Reference: H09/1175/93

Description: Details of tree planting scheme & footway construction
submitted (Conditions 2 and 5 of H09/0970/93)

Location : Jekils Bank Holbeach St Johns
Spalding Lincs

This permission is granted in accordance with the application submitted
as revised by Drawing no: CJB1/1C received by the Local Planning Authority
on 7 January, 1994.

NEW FOOTWAY CONSTRUCTION
SCALE: 1/100.

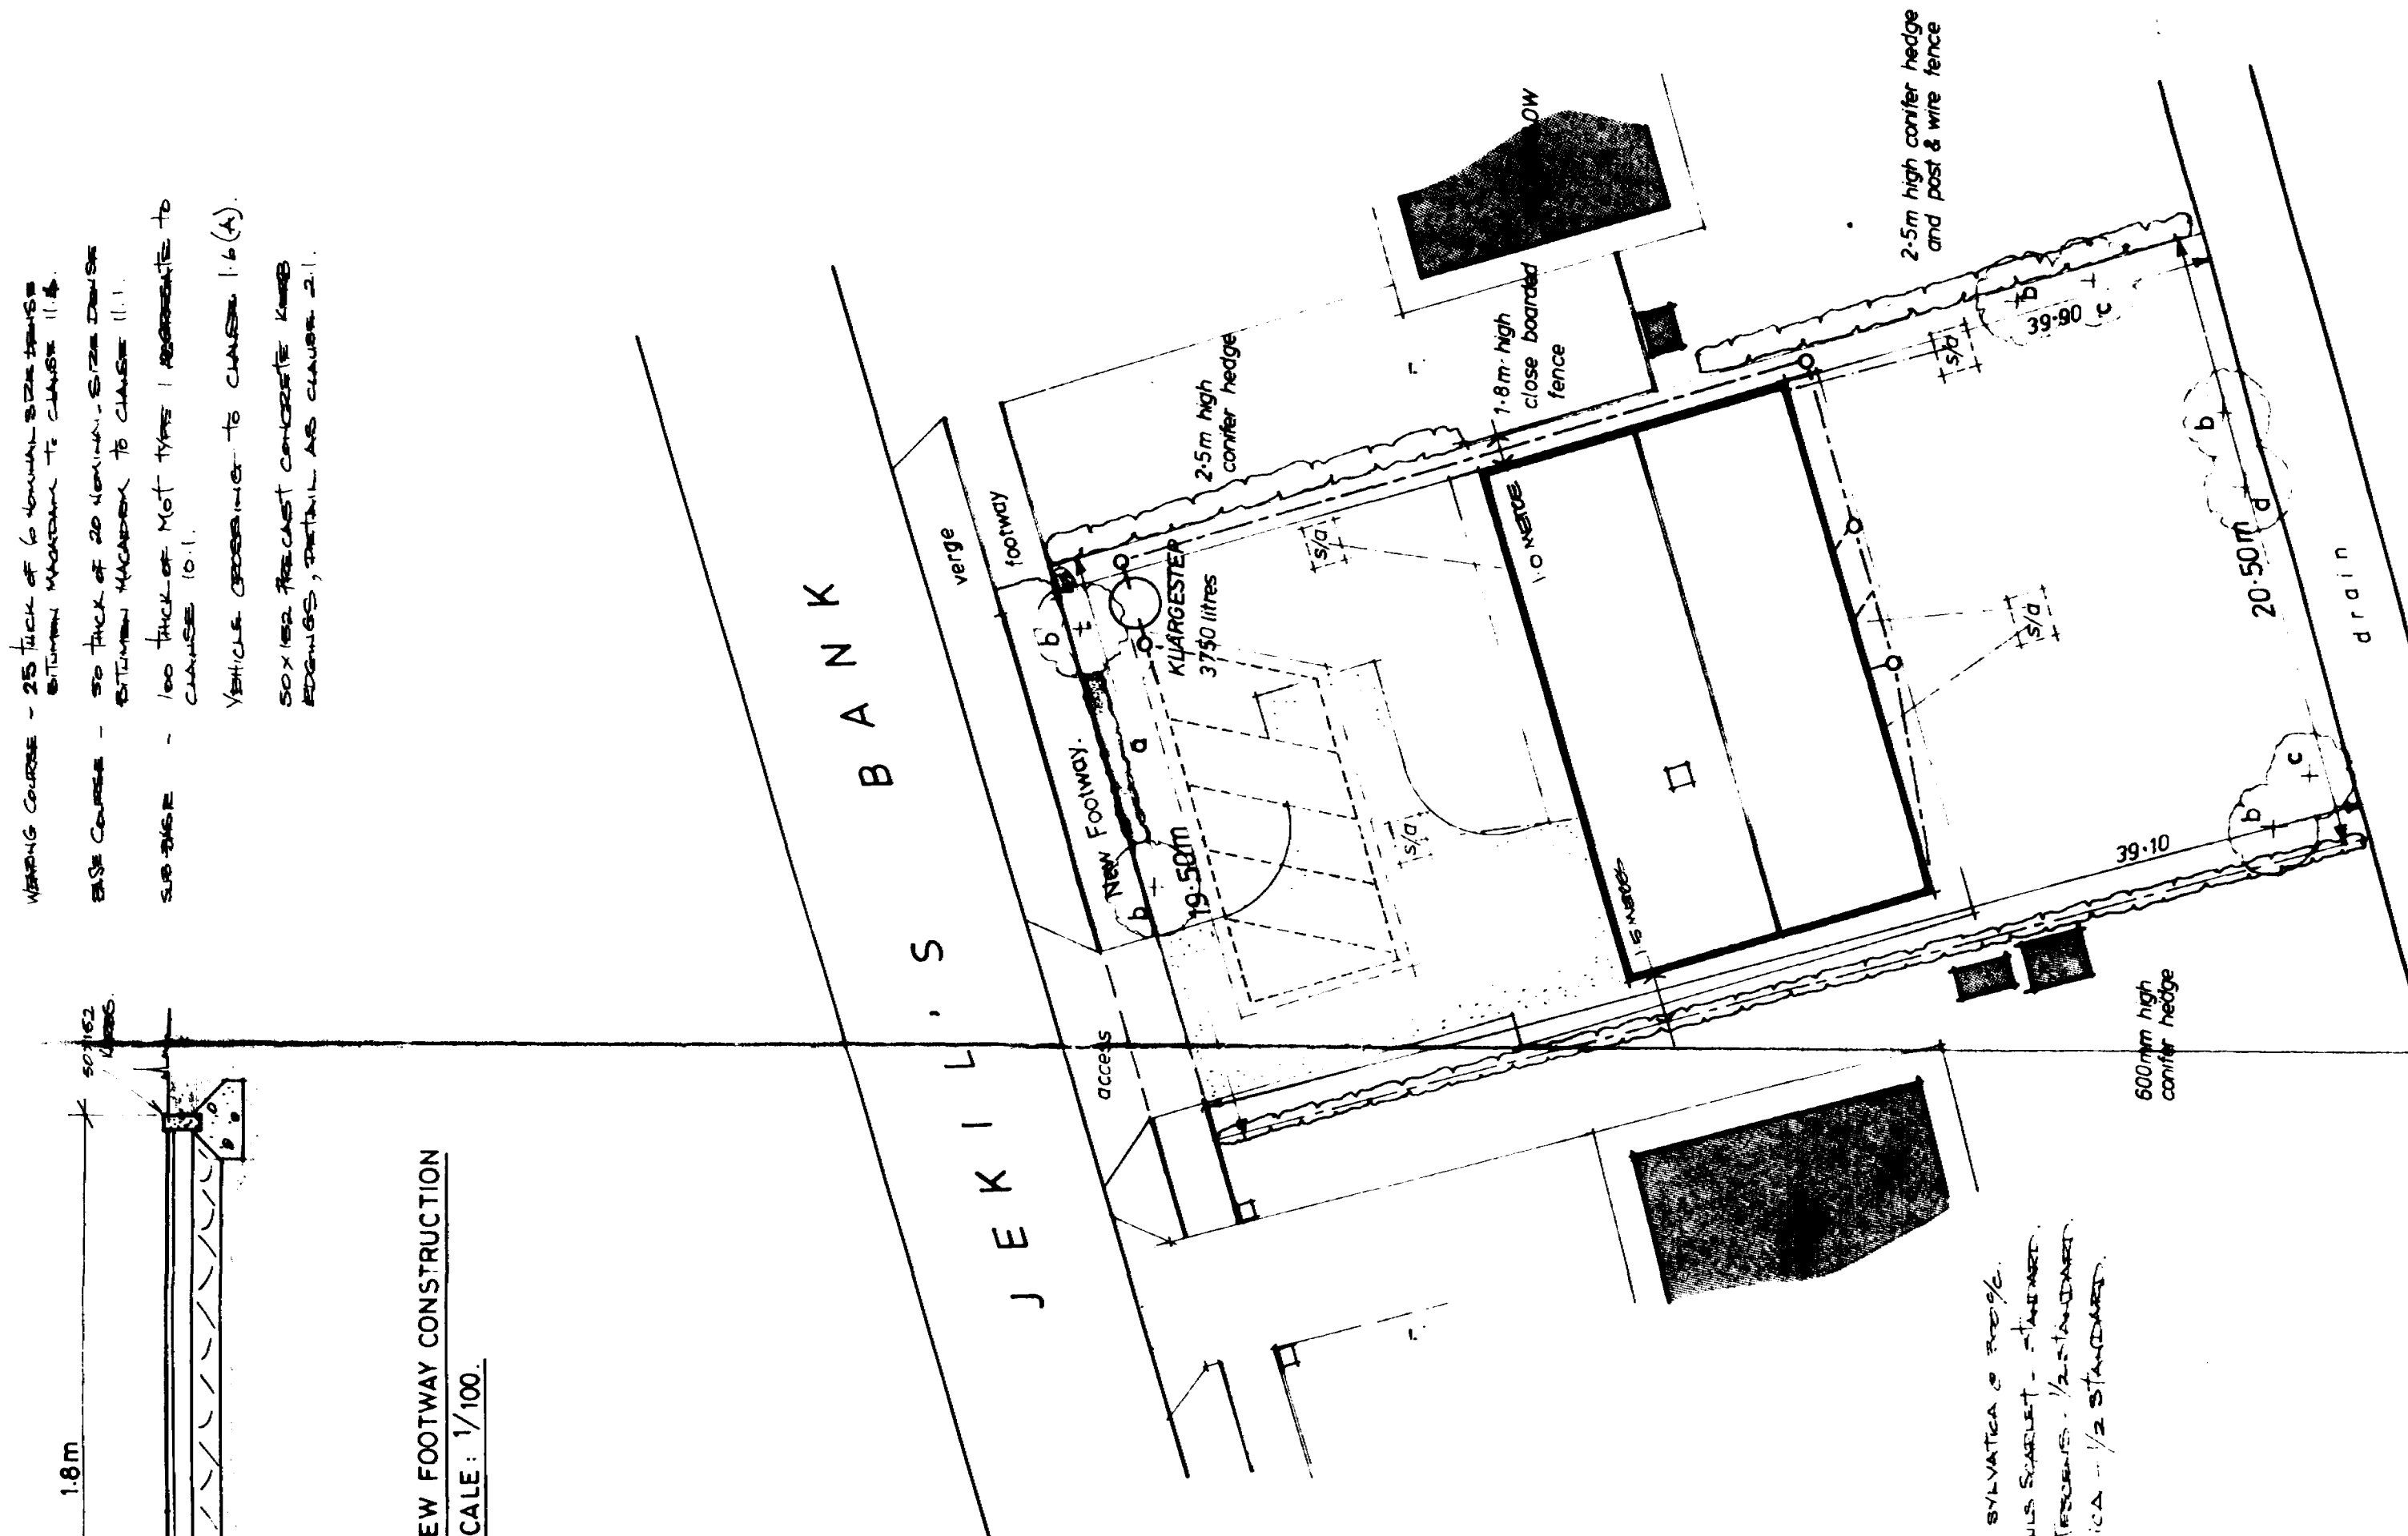
LCC - The weaving course thickness of the footway shall be
25mm thick - otherwise OK CB 22/12/93
- No objection to amended plans for 13/1/94

Amendment: Increase footpath wearing course to 25 mm thick
(drawing number CJB 1/1B)

INCREASE FOOTPATH
WEARING COURSE
TO 25mm THICK.

5.1.94 LICENSE WEARING COVER OF FOOTWEAR TO BE
10.12.93. TREE PLANTING & FOOTWAY DETAILS
11.10.1990. P.2000 APPLICATION.

NEW FOOTWAY CONSTRUCTION
SCALE: 1/100.

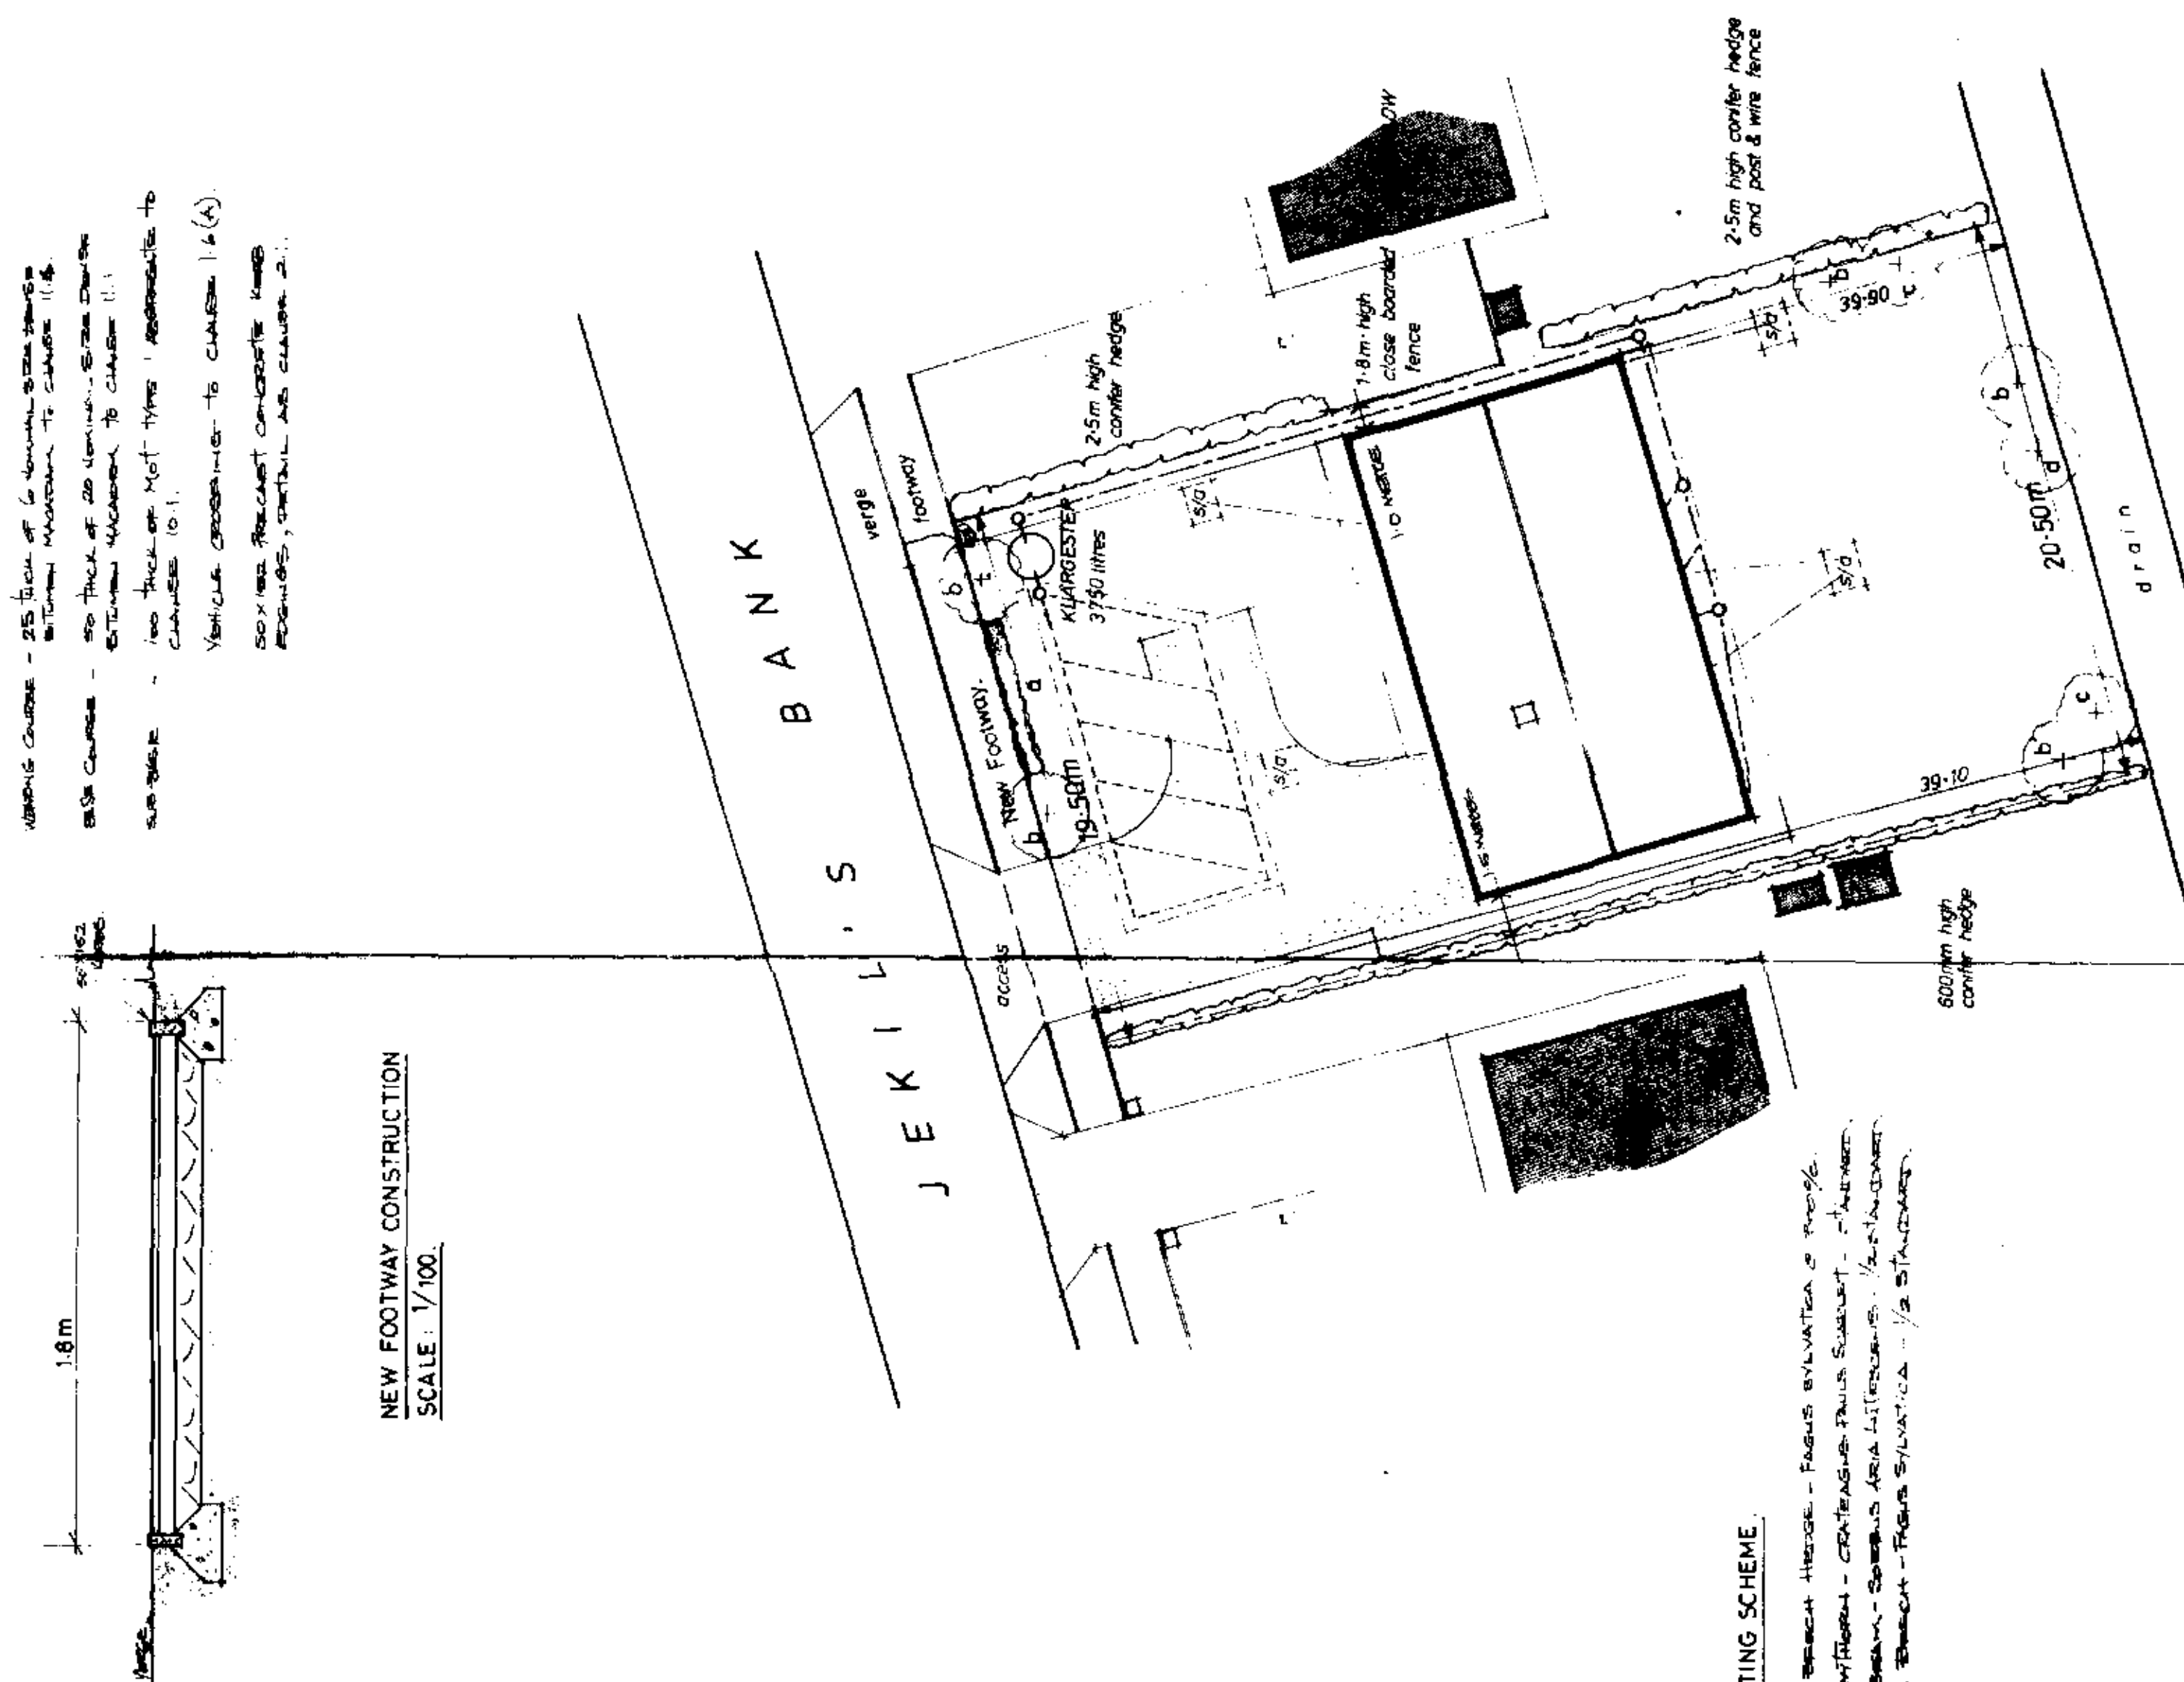
Landscaping scheme considered acceptable (includes frontage hedge)
County Highways raise north to new footway.
